FUSELAGE - WIRE BUNDLE ANCHOR AND FLOOR SUPPORT ANGLE VERIFICATION

A wire bundle anchor and angle support may have been omitted during manufacturing.

SB750-53-34
Page 1 of 7

Figure 1. Wire Bundle Anchor Installation (Sheet 1)

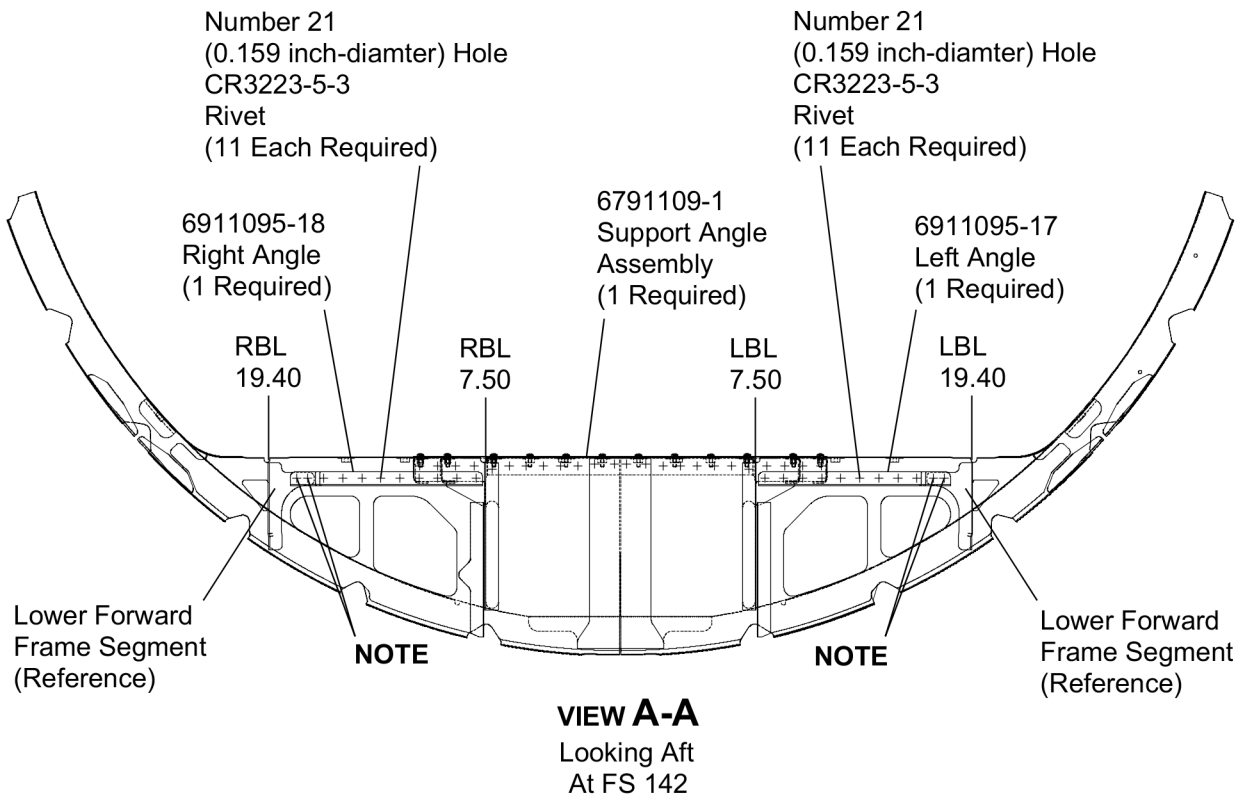
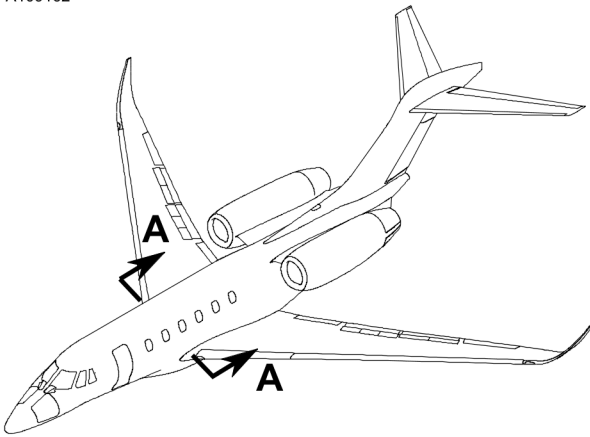
5. (Refer to Figure 1, View A-A, Detail B.) Do an inspection for the 6911095-17 Left Angle and 6911095-18 Right Angle.
 - A. If the 6911095-17 Left Angle is installed, go to Step 6.

- (3) Install the 6911095-17S Left Angle.
- (a) Put the 6911095-17S Left Angle on the lower forward frame segment.
 - (b) Drill 11 Number 21 (0.159 inch-diameter) hole in the lower forward frame segment to match the pilot holes in the 6911095-17 Left Angle.
NOTE: The edge distance (ED) of the two inboard holes must be at least 1.25D edge distance. If the ED is less than this contact Textron Aviation Engineering.

NOTE: The edge distance at these locations must be at least 1.25D.
 If it is less than that contact Textron Aviation Engineering.

Figure 1. Wire Bundle Anchor Installation (Sheet 2)

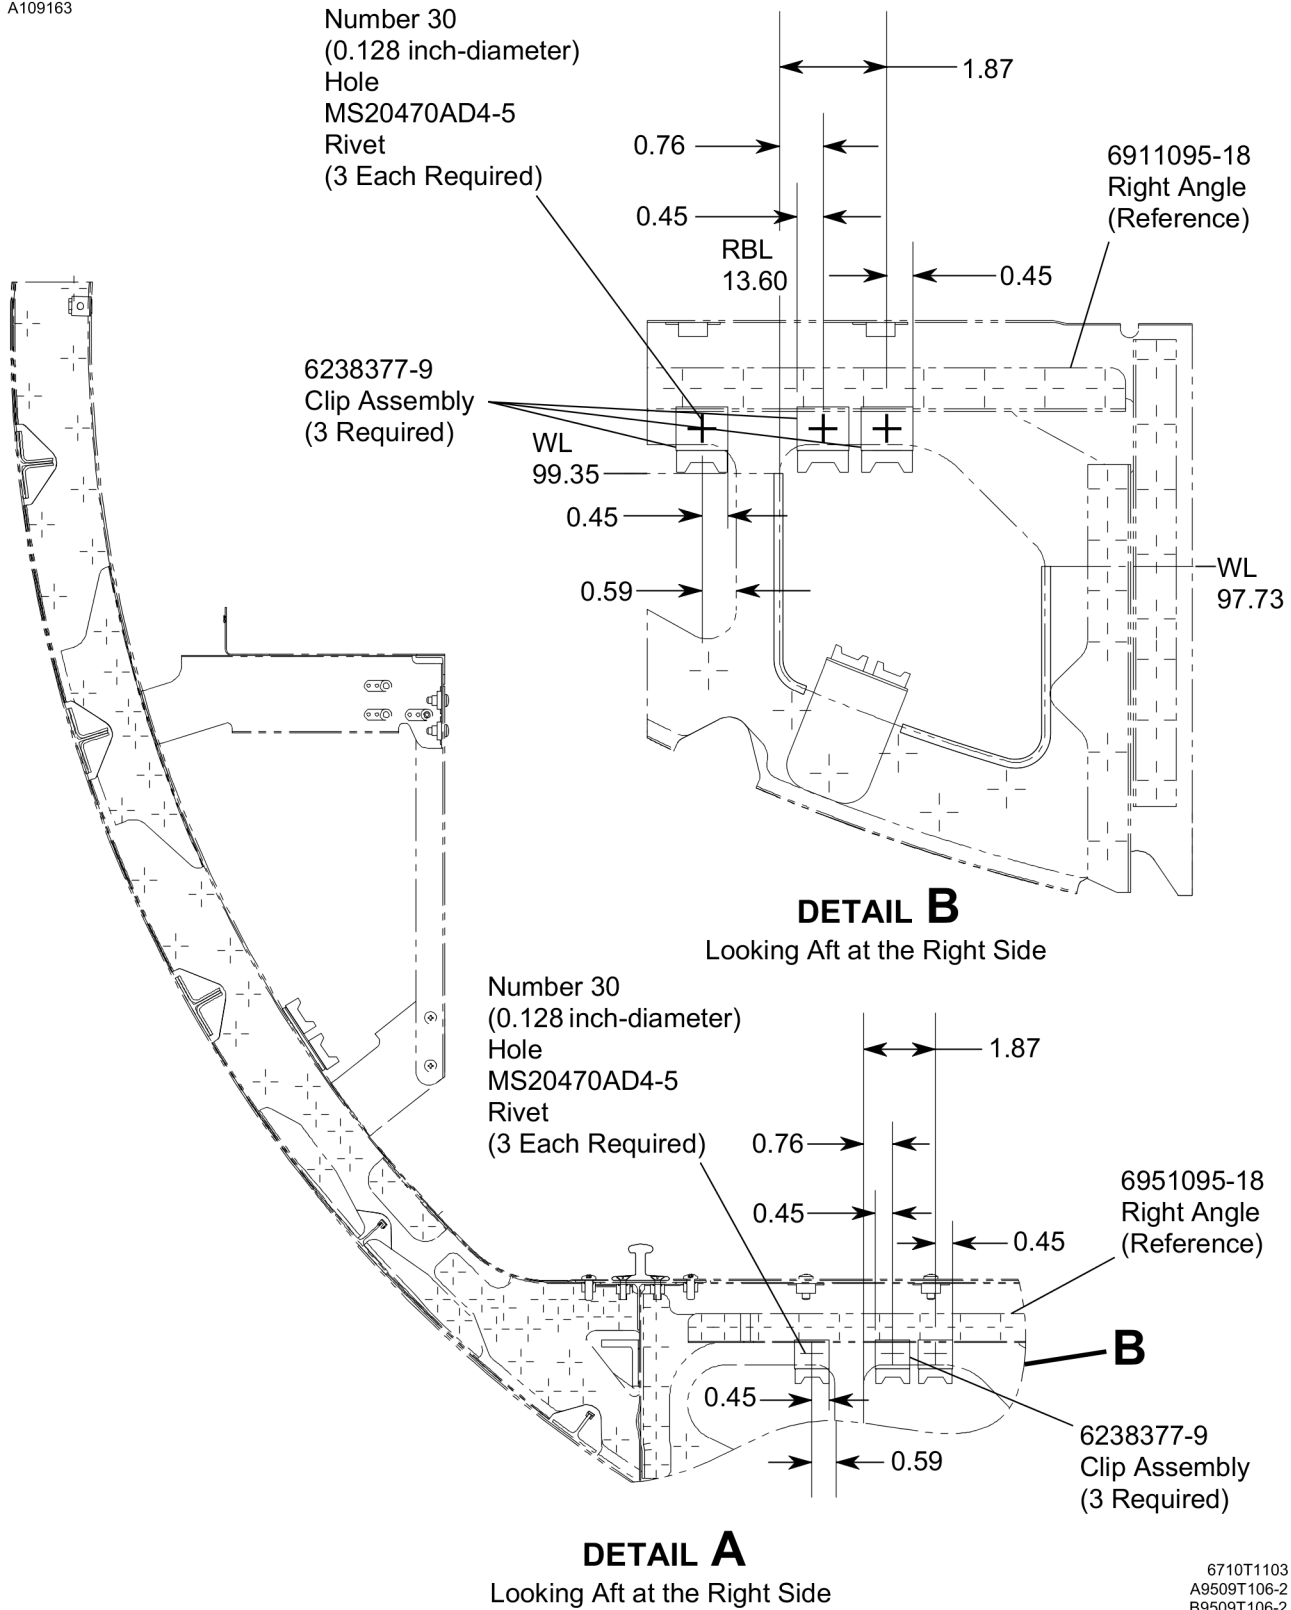
- (4) Go to Step 6.
6. (Refer to Figure 1, View A-A, Detail B.) Do an inspection for the 6911095-18 Right Angle.
- A. If the 6911095-18 Right Angle is installed, go to Step 6.C.

- B. If the 6911095-18 Right Angle is not installed and do the steps that follow:
 - (1) Put the 6911095-18S Right Angle on the lower forward frame segment.

- (2) Drill 11 Number 21 (0.159 inch-diameter) hole in the lower forward frame segment to match the pilot holes in the 6911095-18S Right Angle.
NOTE: The edge distance (ED) of the two inboard holes must be at least 1.25D edge distance. If the ED is less than this contact Textron Aviation Engineering.

- (10) Attach the 6238377-9 Clip Assemblies to the aft side of the frame segment with one CR3223-5-3 Rivet.
NOTE: It is permissible to install the 6238377-9 Clip Assemblies on the forward side of the frame segment as long as they don't create interference with the 6911095-17S Left Angle and/or 6911095-18S Right Angle. If there is interference then they need to be on the aft side of the frame segment.
